REVISED RESPONSE TO REQUEST FOR ADDITIONAL INFORMATION

APR1400 Design Certification

RAI No.: 401-8402
SRP Section: 19.03 – Beyond Design Basis External Event (APR1400)
Application Section: 19.3
Date of RAI Issue: 02/08/2016

Question No. 19.03-18

Figure 1 –Locations for ECSBS connection

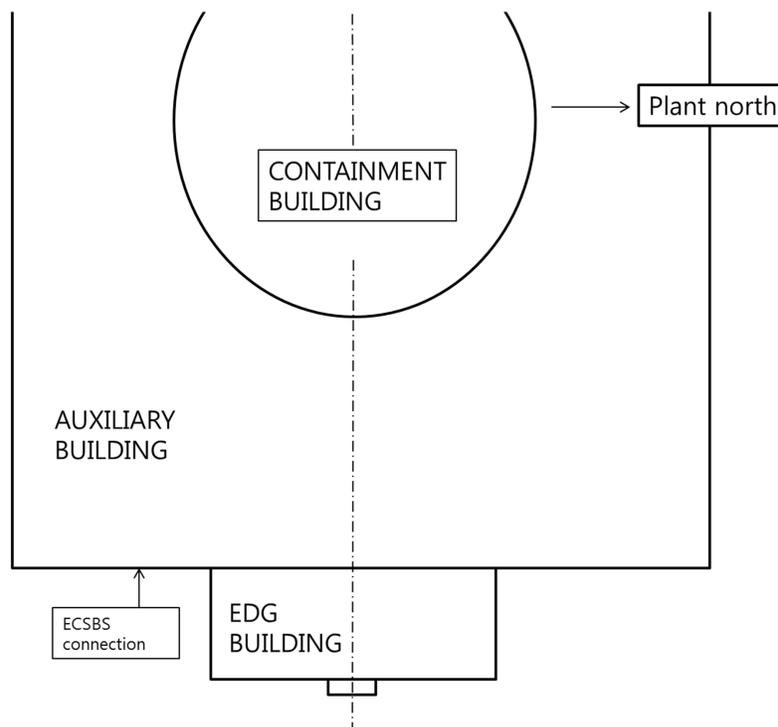
Technical Report APR1400-E-P-NR-14005-P does not contain simplified drawings to show how the FLEX strategy, using the emergency containment spray backup system (ECSBS), is used to maintain containment capabilities. The staff requests that the applicant provide a simplified drawing(s) that identifies the flow path to deliver water to containment. For example the drawing should depict plant piping, valves, pumps, water sources, power needs (as applicable), and any

associated connections (FLEX pump suction, FLEX pump discharge, and fuel supply) and support systems. The staff also requests that the applicant provide the quality classification of installed structures, systems, and components used to maintain containment capabilities. Additionally, the location for any connections should be identified.

The ECSBS can use an external water source from the RWT using the ECSBS FLEX pump, which is connected to the ECSBS via a fire siamese connection located outside of the [Auxiliary Building](#). Please refer to [Figure 1](#) below for illustration. The ECSBS line runs inside the containment building from the fire siamese connection to the ECSBS nozzles.

The ECSBS FLEX pump is self-powered pump (diesel-driven). And the pump is connected to the RWT via a flexible hose on the suction side and is connected to the fire siamese connection via a flexible hose on the discharge side. Fuel is supplied from the diesel fuel oil day tank “A/B” as illustrated in Figure 6-6 of the Technical Report APR1400-E-P-NR-14005-P. [The quality classifications of installed structures, systems, and components used to maintain containment capabilities \(Containment Building, Auxiliary Building, and components of Containment Spray System\) are described in DCD Tier 2 Table 3.2-1 \(Page 1, 12, and 13 of 86\) and Figure 6.2.2-1.](#) A new schematic drawing (Figure 6-7) will be added to the next page of Figure 6-6 and Subsection 5.1.2.5.3 will be revised as indicated in the Attachment.
